**DEPARTMENT OF TRANSPORTATION  
STATE OF GEORGIA**

**FILE** P.I. # 0003948 **OFFICE** Design Policy & Support  
STP00-0003-00(948)  
Catoosa County  
GDOT District 6 - Cartersville **DATE** 9/11/2013  
SR 3 @ CR 381/Graysville Road  
Roundabout

**SUBJECT** APPROVED REVISED CONCEPT REPORT

**DEPARTMENT OF TRANSPORTATION  
STATE OF GEORGIA  
REVISED PROJECT CONCEPT REPORT**

REVISION DATES			STATE OF GEORGIA DEPARTMENT OF TRANSPORTATION OFFICE: DISTRICT SIX DESIGN <b>TYPICAL SECTIONS</b>	
			SR 3/US 41 @ GRAYSVILLE RD	
			DRAWING NO. 5-001

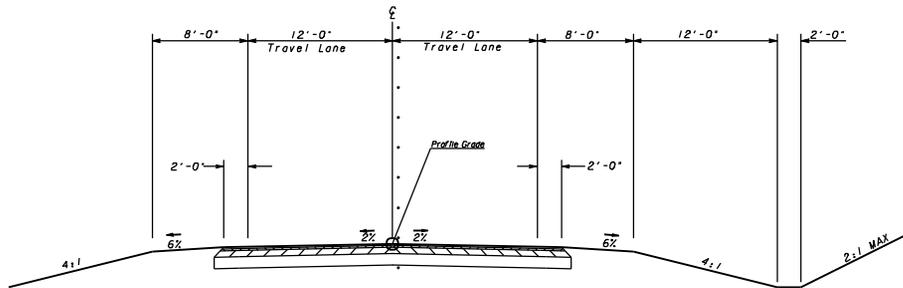
<b>Approved Features:</b>	<b>Proposed Features:</b>
<p><b>Approved Typical Section:</b> SR 3: 3-12 ft travel lanes, one in each direction with a 12 ft left turn lane southbound and a 12 ft right turn lane northbound. Shoulders will be 10.5 ft; 6.5 ft paved and 4 ft grassed.                      CR 381: 3 12 ft travel lanes, one in each direction with a 12 ft left turn lane. Shoulder will be 10 ft, 4 ft paved and 6 ft grassed.                      Turning lanes and paved shoulders are not needed for roundabouts.</p> <p><b>Approved Project Termini:</b>                      SR 3: MP 10.72 to 11.03                      CR 381: MP 0.00 to 0.10                      Eliminating the turning lanes allows for less widening (due mostly to the removal of storage length) on the approaches compared with a roundabout.</p> <p><b>Approved Right of Way Requirement:</b>                      Catoosa County shall be responsible for the acquisition of all required Right of Way for this project.</p>	<p><b>Typical Section:</b> Each approach will consist of 2-12 ft. lanes with curb and gutter. Sidewalk will be set back 2 feet from the back of curb.</p> <p><b>Project Termini:</b> Project will begin at MP 10.76 on SR 3/US 41 and end at MP 10.89 for a total project length of 0.13 miles.</p> <p><b>Approved Right of Way Requirement:</b>                      Acquisition of Right of Way will now be handled by GDOT. The revised design will also reduce impacts to historic resources in the area.</p>

<p><b>Reason(s) for change:</b> All of the above changes are results from altering the project from a traffic signal with multiple turn lanes to a single lane roundabout.</p>
